Proposed Revisions to a Standard Plans Index

Originator:	Turley, Joshua	Index Number:	630-010
Date:	5/15/2025	Sheet Number(s):	Sheets 1,2,4
E-mail:	Joshua.Turley@dot.state.fl.us	Index Title:	CONDUIT DETAILS - EMBEDDED

CONDUIT DETAILS - EMBEDDED

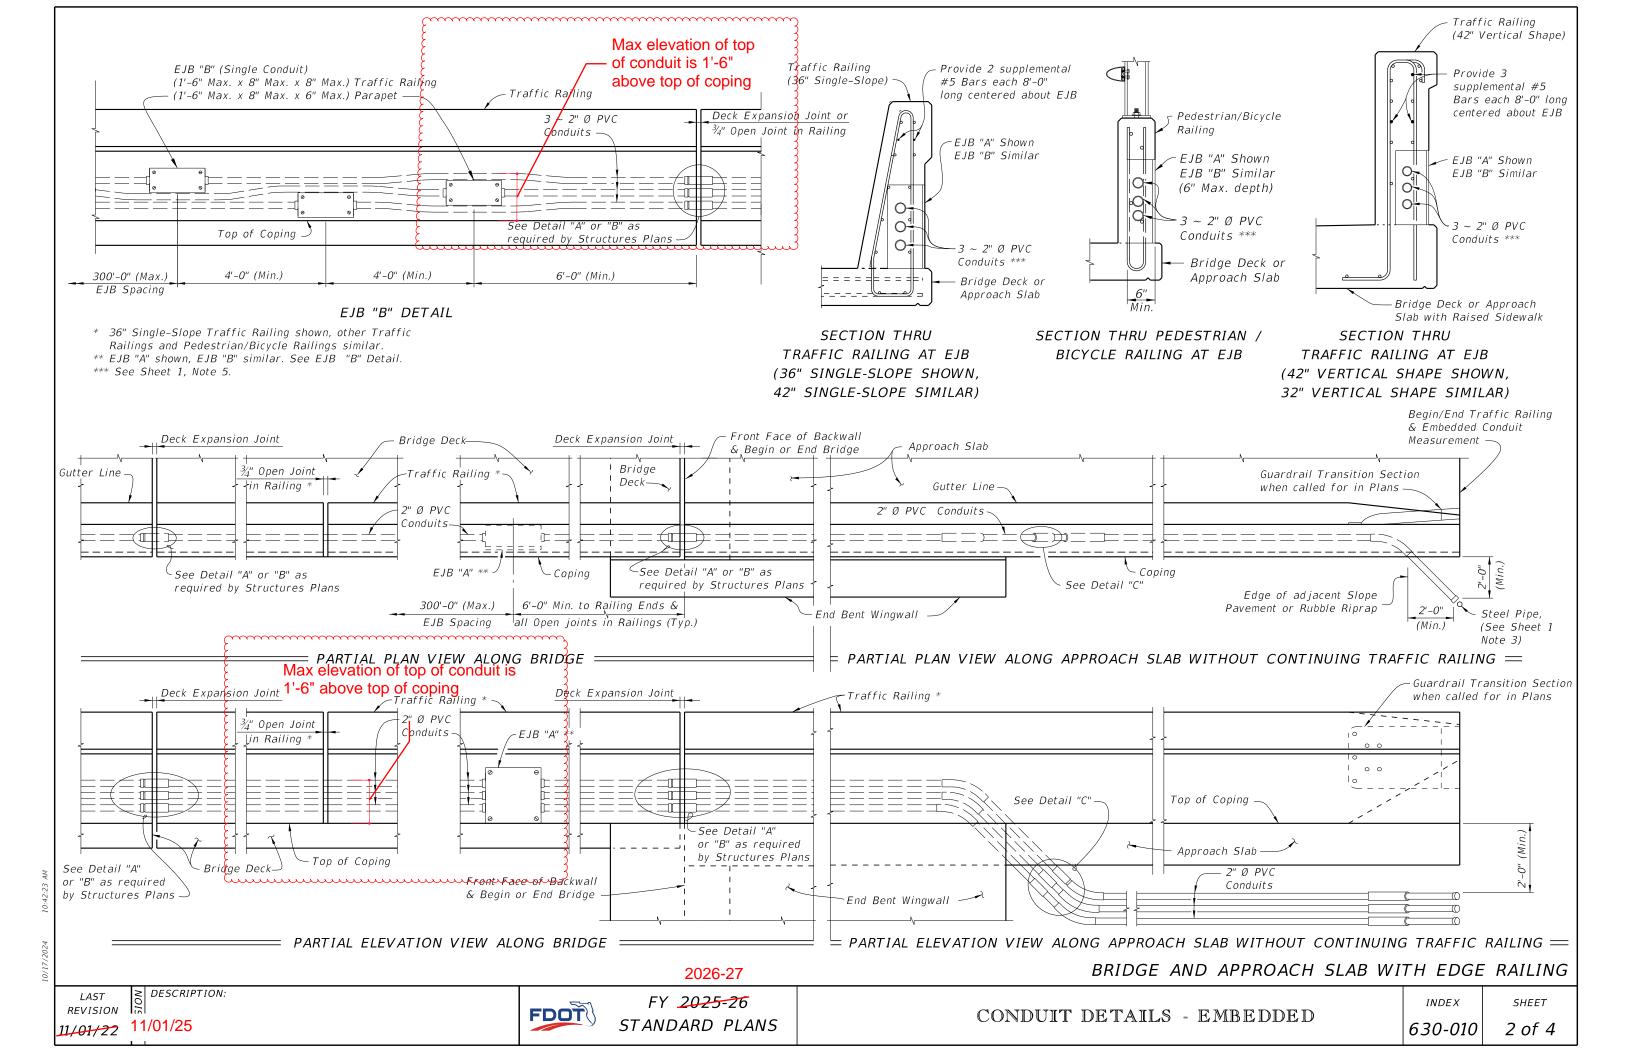
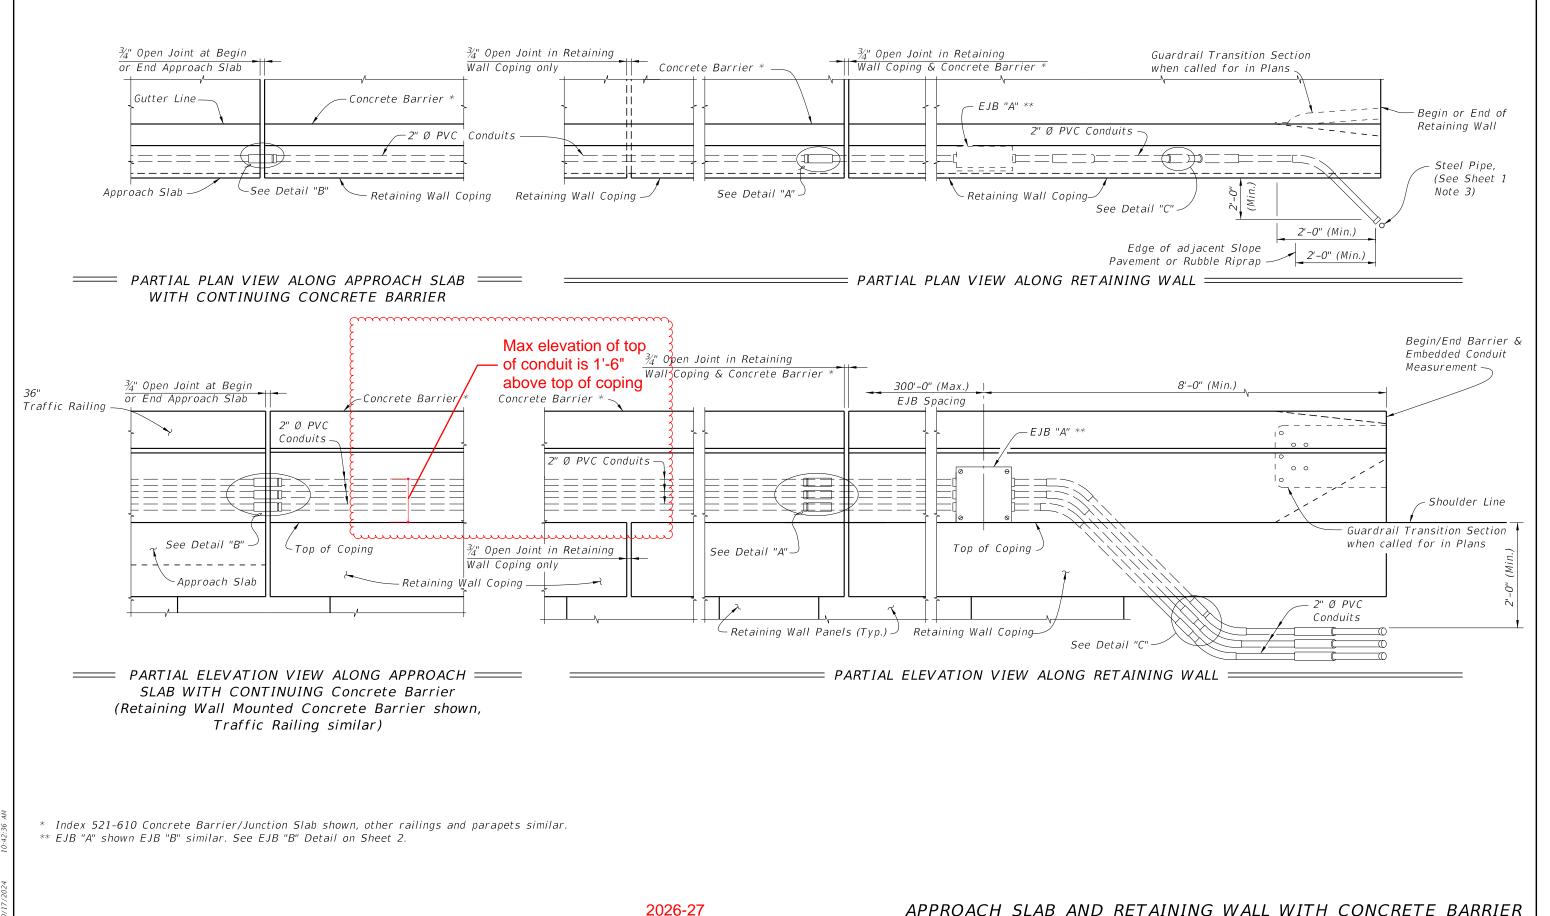
Sheet 1: Added to note 5 a max height to conduit.

- 5. Place conduits as indicated in this Standard unless Structures Plans indicate fewer. Max elevation of the top of conduit is 1'-6" above top of coping for traffic barriers and 1'-2" for parapets.

Conduit height in the barrier is being limited to avoid conflicts with conduits when drilling holes for anchorage. This aligns with changes to Index 700-012, where the sign mounting plate was raised.

4 of 4

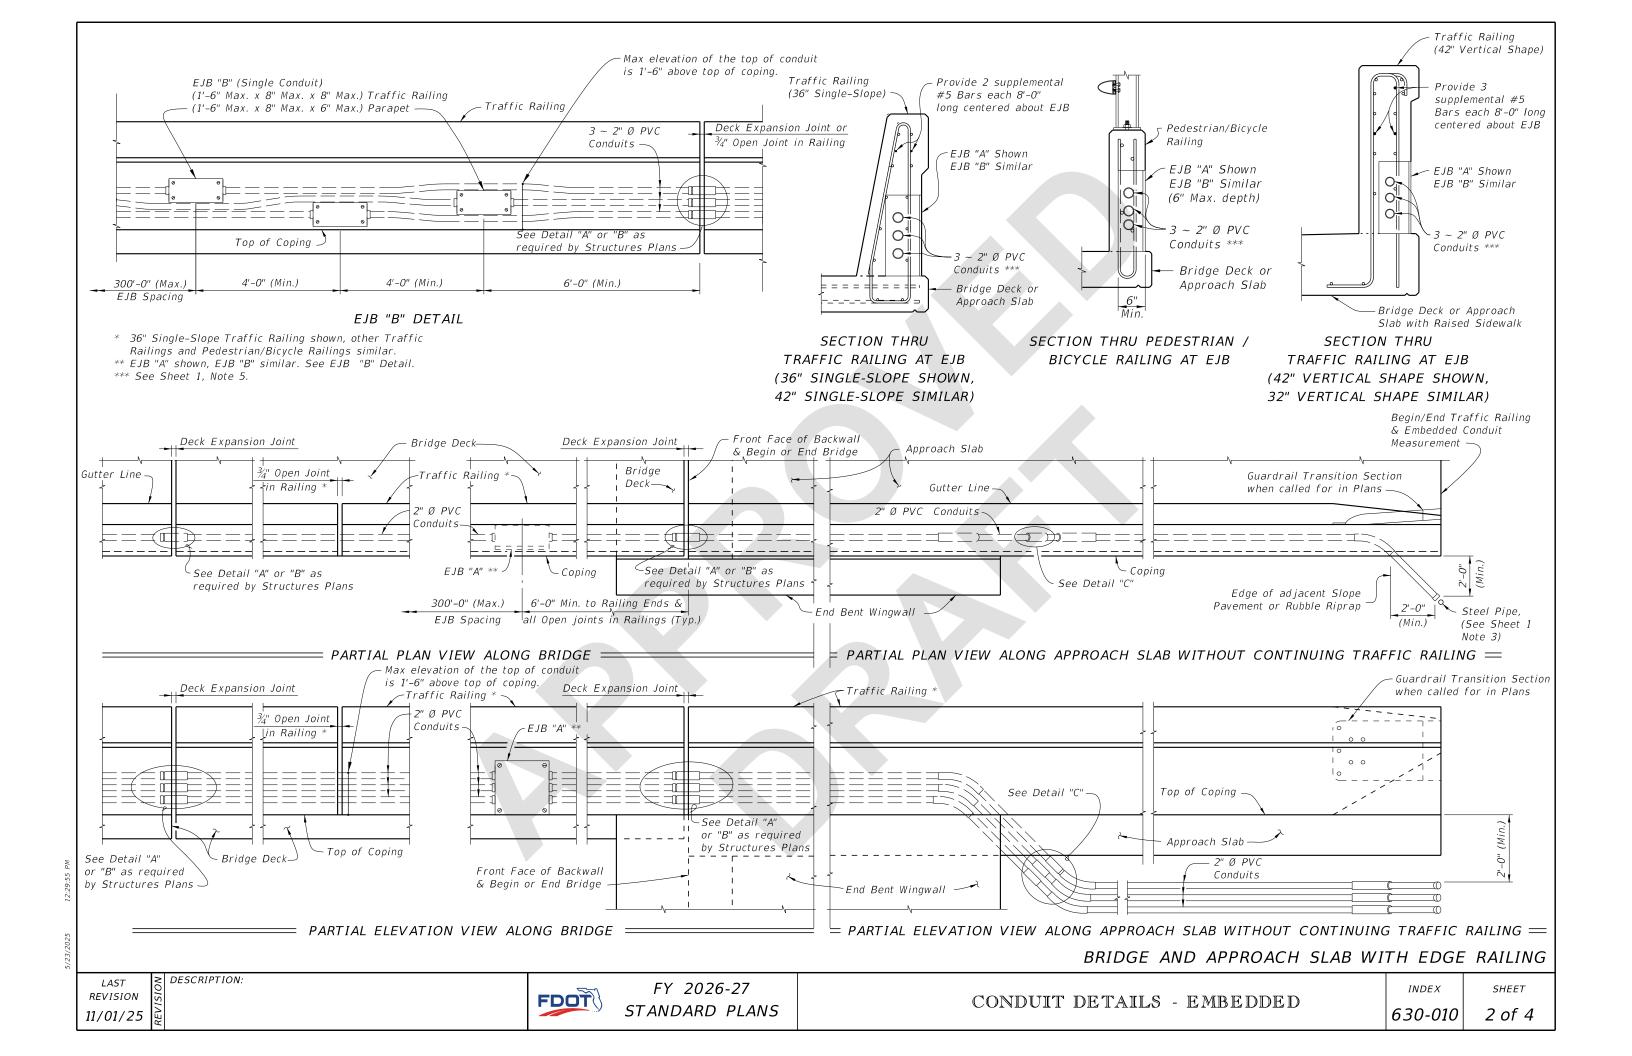
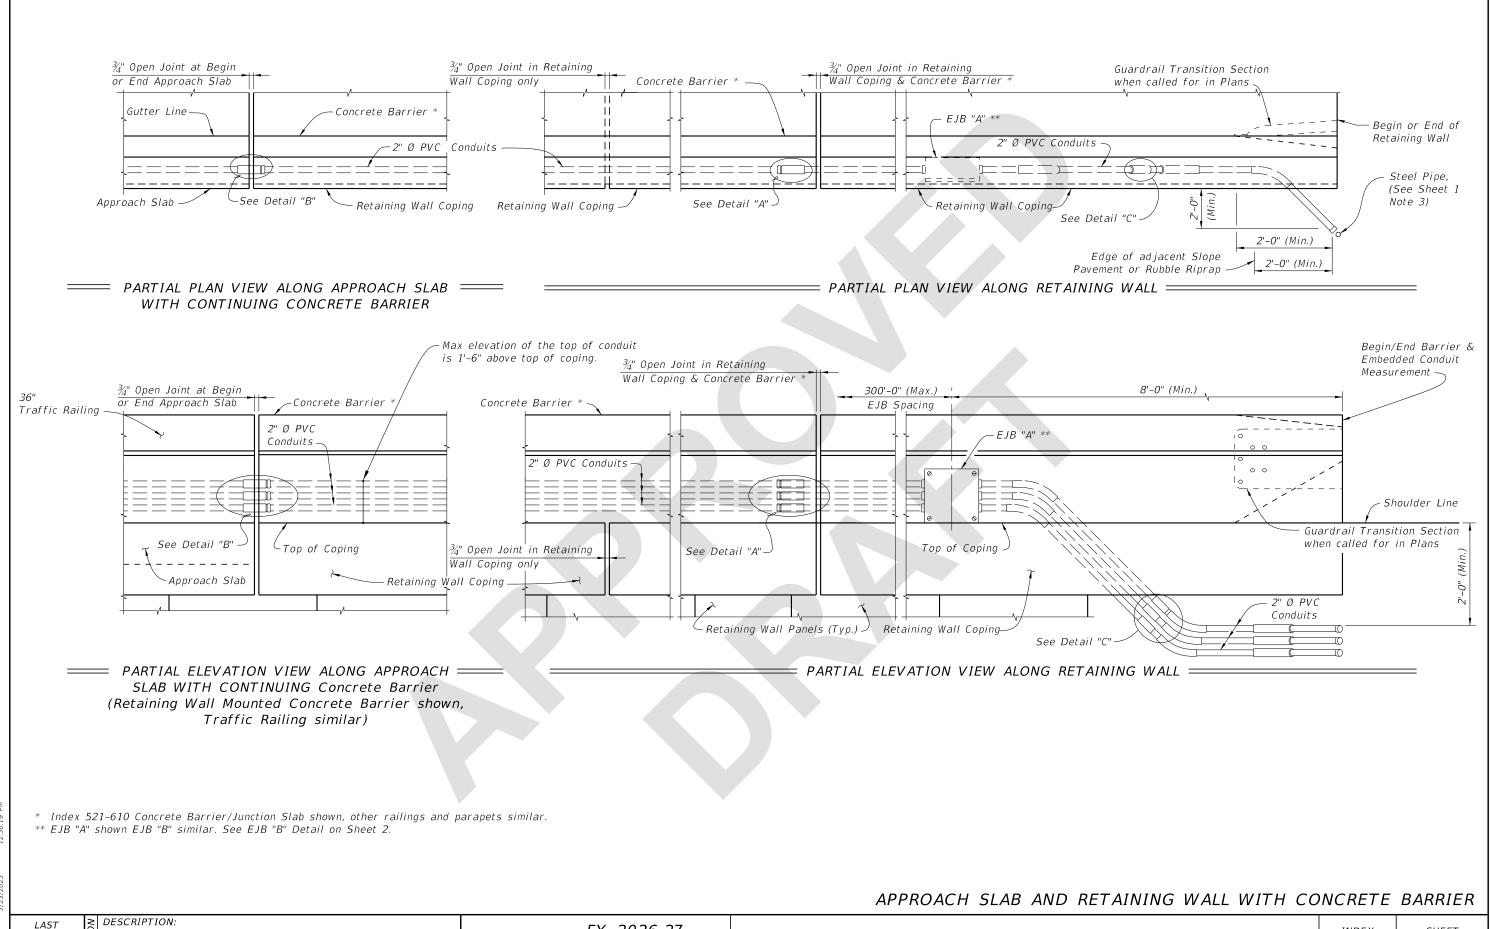
Sheet 4: Added a max elevation for conduit in PARTIAL ELEVATION VIEW ALONG APPROACH
